## COAL MINING AND RECLAMATION PERMIT APPLICATION TO REVISE A PERMIT (ARP)

**Permit Number:** D-425  
**Application Number** R-425-13

**ARP Type:**  
Add Sediment Pond

## APPLICATION TO REVISE A COAL MINING PERMIT

## As-Built Pond EBS-3 Plan View

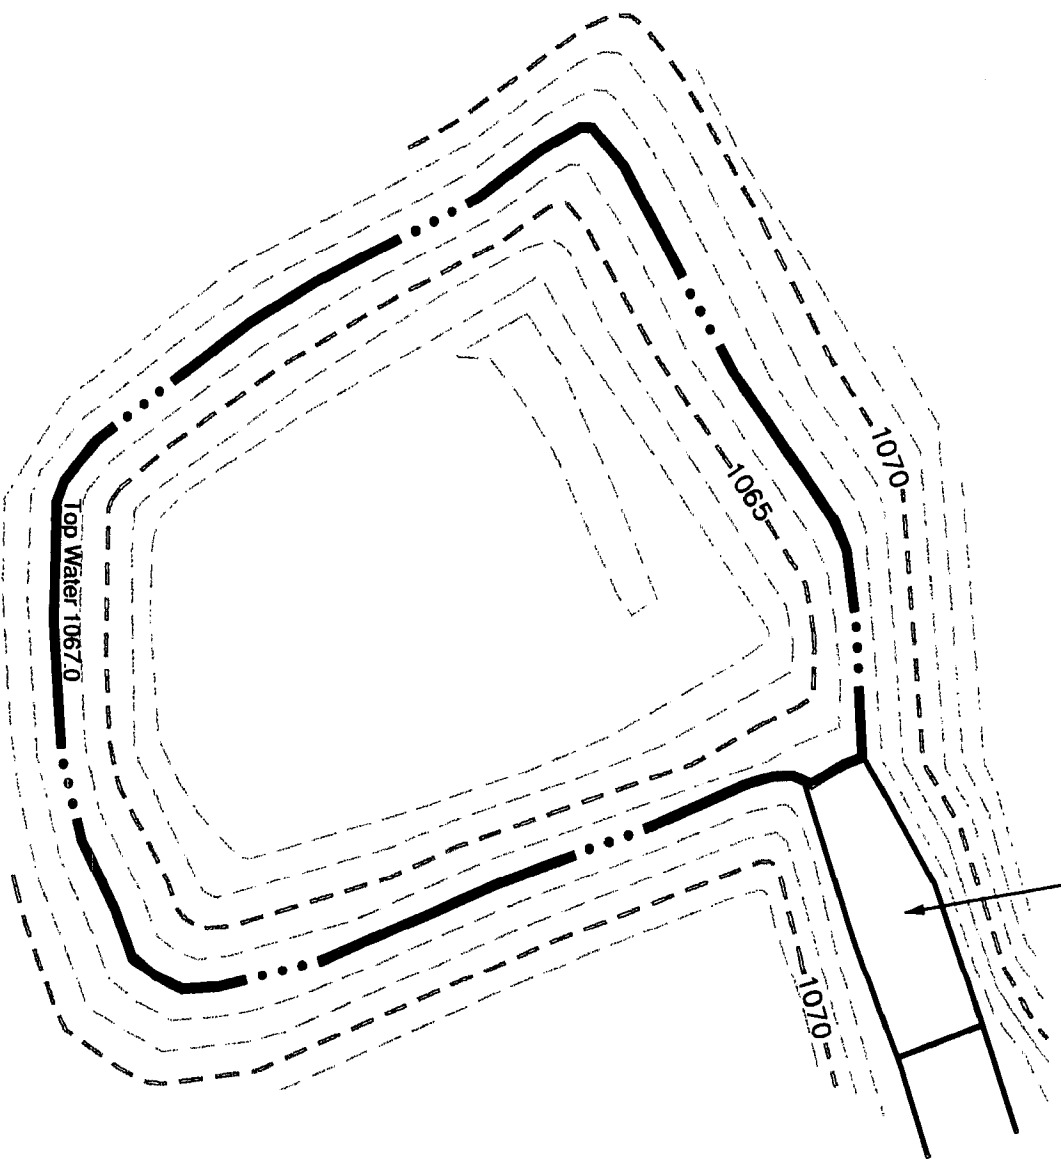
To add pond EBS-3 to the drainage control plan.  
SEE ATTACHED ADDENDA.

To provide sediment control for the affected area. Pond EBS-3 will be used in lieu of ponds EBS-1 and EBS-2 due to the decreased area disturbed. The shaft will not be constructed at this location. Only minor disturbance occurred on the area prior to determining that the site would have to be abandoned. Reclamation is completed as shown on the attached map and all areas to be reclaimed have a good stand of vegetation.

PROFILE LOOKING WEST

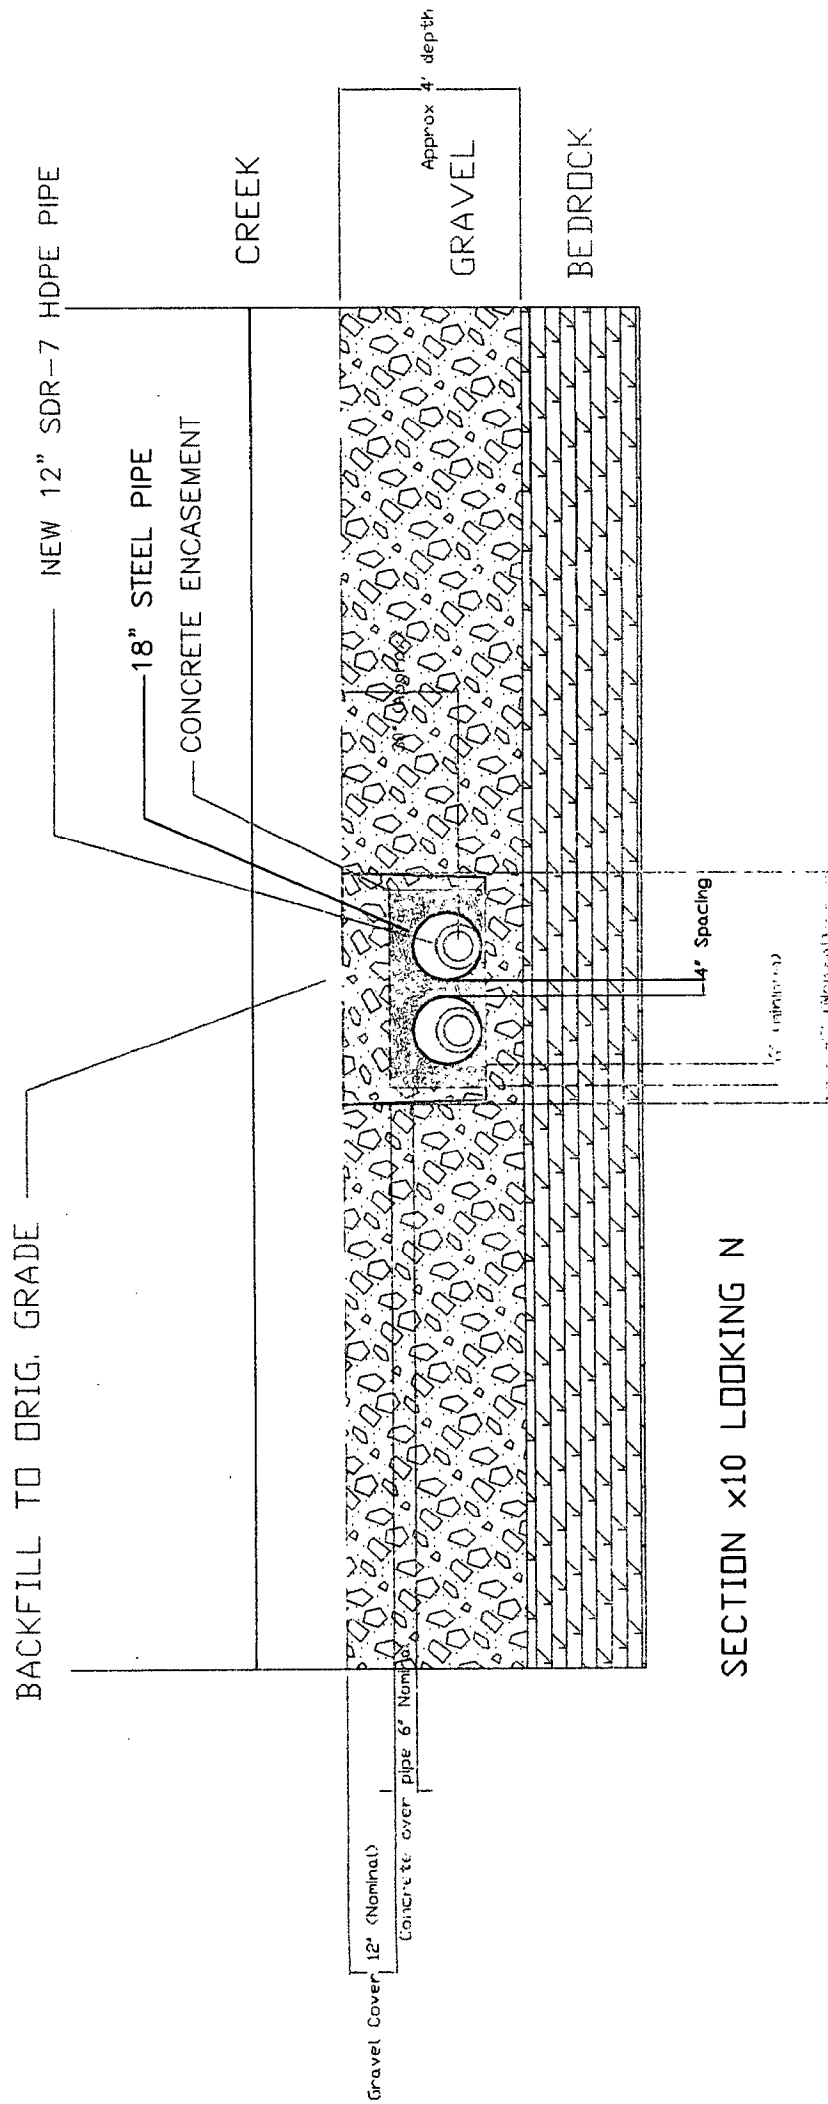
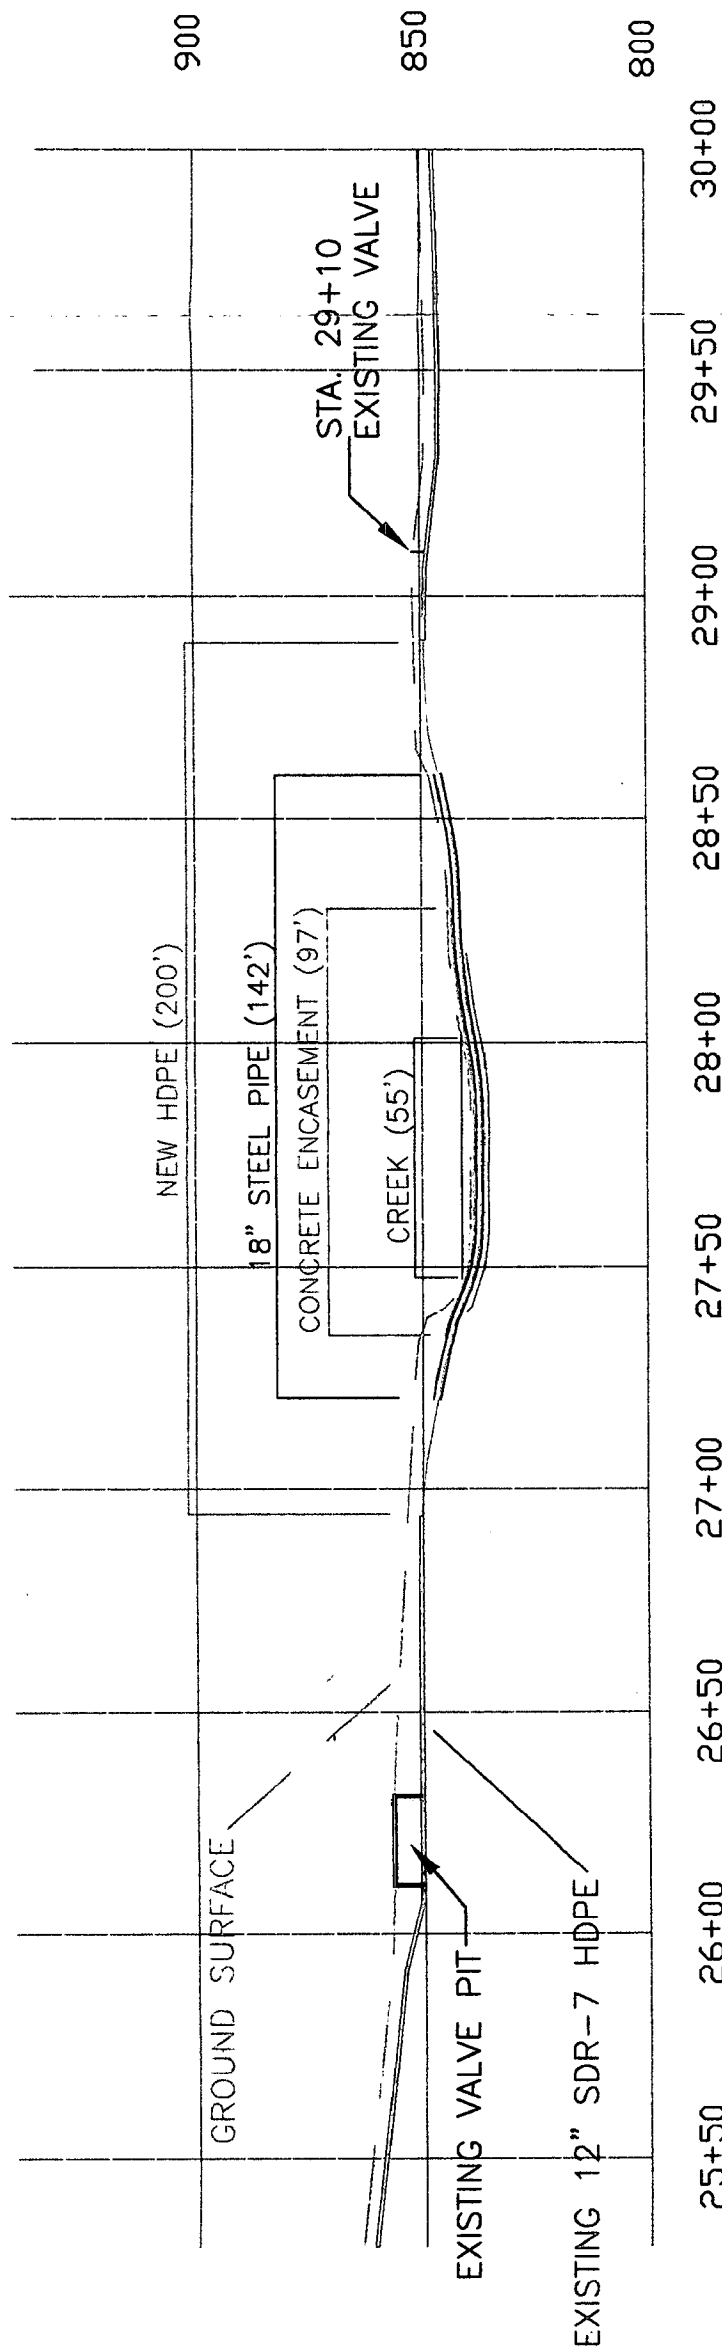
The proposed in-stream replacement of the damaged pipelines is planned as follows;

A coffer dam/roadway (fill) will be constructed from one bank to approximately half-way across the stream. A trench will be dug through this fill and into the underlying gravel of the creek bed starting several feet back from the creek end of the fill. The steel casings will be installed in the trench. A 35,000 psi concrete, standard used by ODOT, will be poured over the steel casings. When the concrete has cured, it will be covered with the streambed material, with the end exposed. Then the other half of the coffer dam/roadway and trench will be constructed removing material from the first-half fill. The stream is now diverted over the first-half (completed) side of the crossing. The other steel culverts will be put in place and welded. Concrete will be poured over the casings, will cure, and be covered with the stream bed material. The HDPE pipe will then be pulled through the casings, already in place.

The mass of concrete, rigidity of the steel encasement, and the tension of the HDPE pipe lines attached at the north and south ends to the remainder of the pipeline will prevent the pipe crossing structure from moving downstream during storm events. The fact that the damaged structure in its current location has withstood a similar flooding event, with debris creating additional pressure from the upstream end, is proof of the strength of the steel encasement and HDPE pipe.

A.R.P. MAP  
PERMIT D-0425

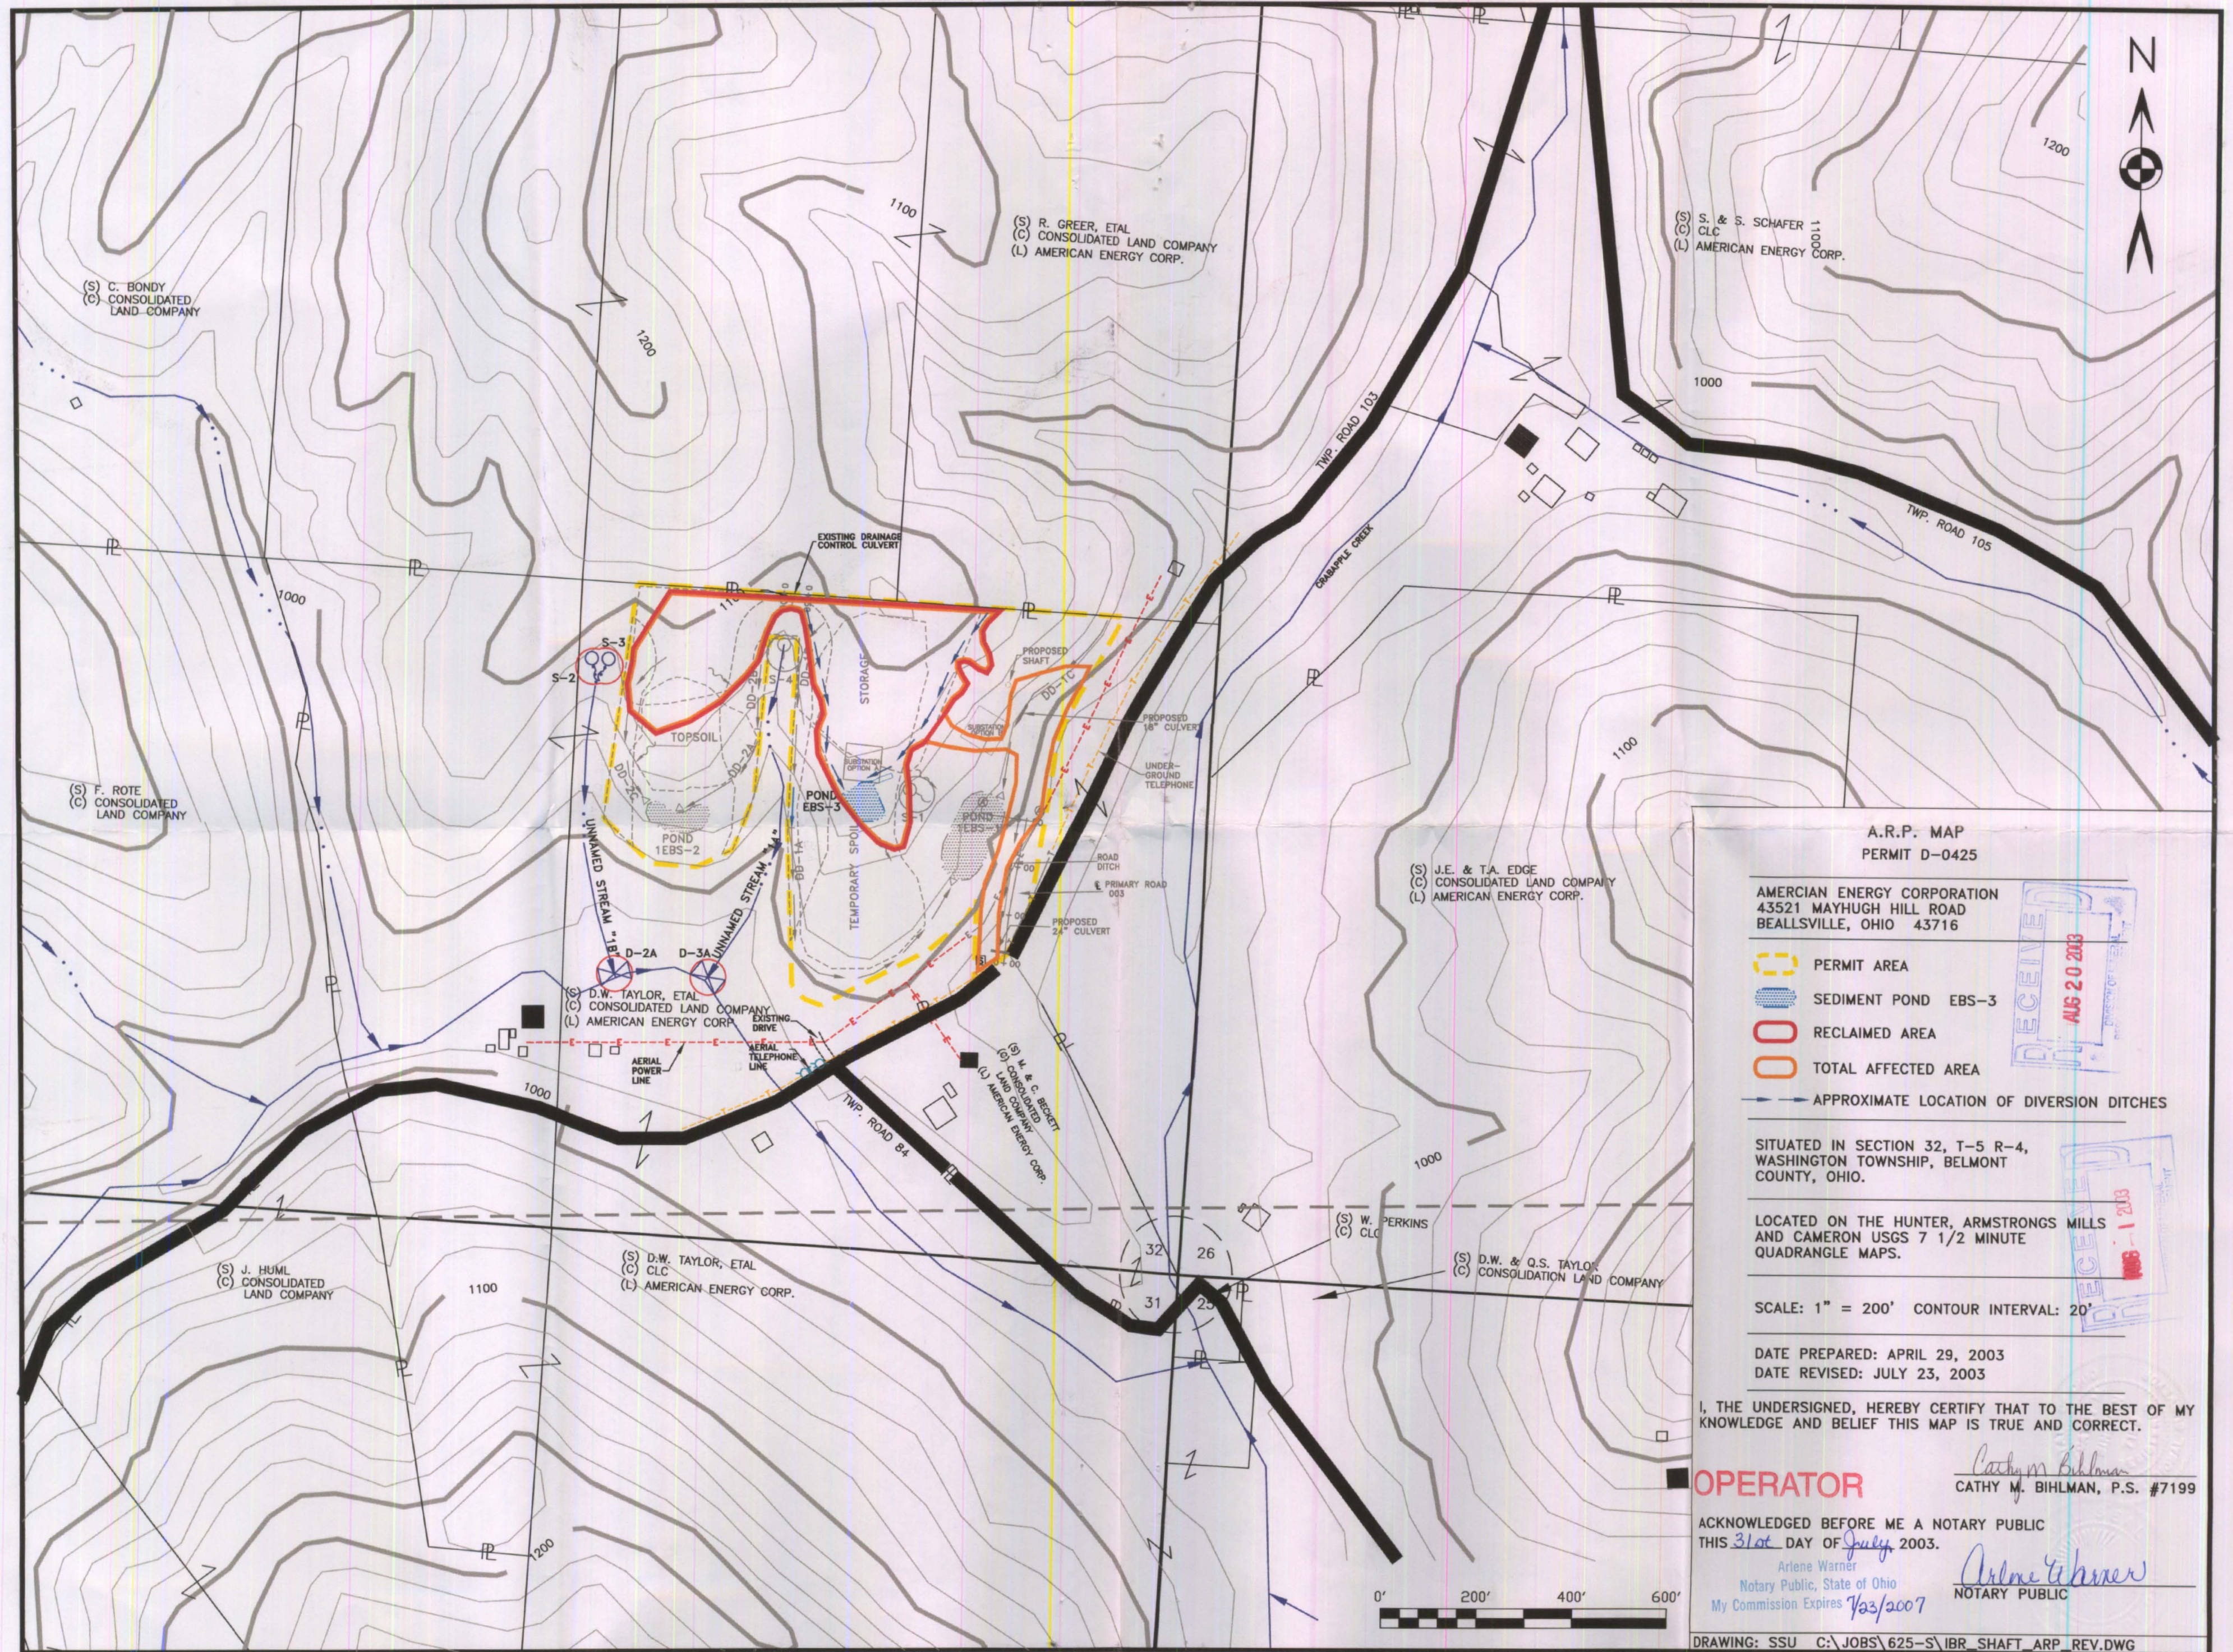
1. Revised to show the disturbed area and diversions directing drainage to Pond EBS-3 on the map as requested.

Provided a revised map date.
